UNITED STATES DEPARTMENT OF COMMERCE
United States Patent and Trademark Office

APPLICATION NO.	FILING DATE	FIRST NAMED INVENTOR	ATTORNEY DOCKET NO.
09/214,519	01/07/99	HASHIZUME	T 101850

Office Action Summary

This office action is in response to request by applicant of 4/26/01, Paper No. 19 to further identify the cited prior art. Examiner has included US Patent Numbers for applicant's easy reference.

FIG. 5

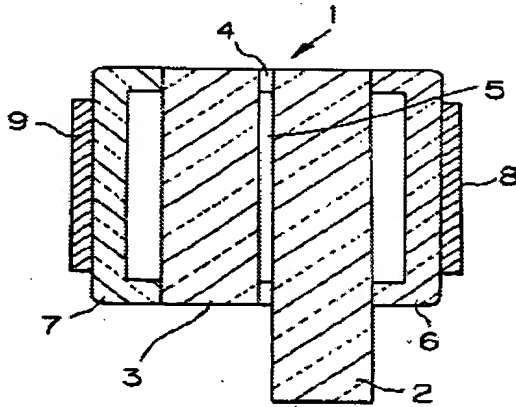
Regarding claims 1 and 4 (amended), Yamada et al. disclosean optical modulation element[Fig 5, #5] a transparent plate [Fig 5, #3] secured to the optical modulator a projection unit [Fig.2, #209].

Regarding claims 2 and 9 (amended), Yamada et al. disclosea polarizer [Fig 5, #9] bonded to the transparent plate.

Regarding claim 6 (amended), Yamada et al. disclose the transparent plate [Fig 5, #3] thickness is larger than the focal length of the projection lens [Fig 2, #209].

Regarding claim 8 (amended), as best the examiner is able to ascertain, Yamada et al disclose a polarizer [Fig 5, #9] and a pair of substrates [Fig 5, #2 and #3]

Applicant states on page 2, "As agreed during the personal interview, Yamada does not disclose or suggest an optical modulation device, and a transparent plate formed on at least one surface of the optical modulation device, as recited in amended claim 1." Examiner respectfully suggests that there was miscommunication during the interview and Examiner wishes to correct the record as below. Yamada teaches an optical modulation device [Fig 5, 5] and in column 3 which is reproduced for applicant's convenience:

Applicant states on page 2, "as agreed during the personal interview, Yamada does not disclose or even suggest a transparent plate formed on an optical modulation device. Accordingly, claim 1 is not anticipated by Yamada." Examiner respectfully disagrees with supra statement that examiner agreed with applicant that Yamada does not teach a transparent plate. Examiner wished to correct the record as below. Yamada teaches a transparent plate [Fig 5, 6 and 7].
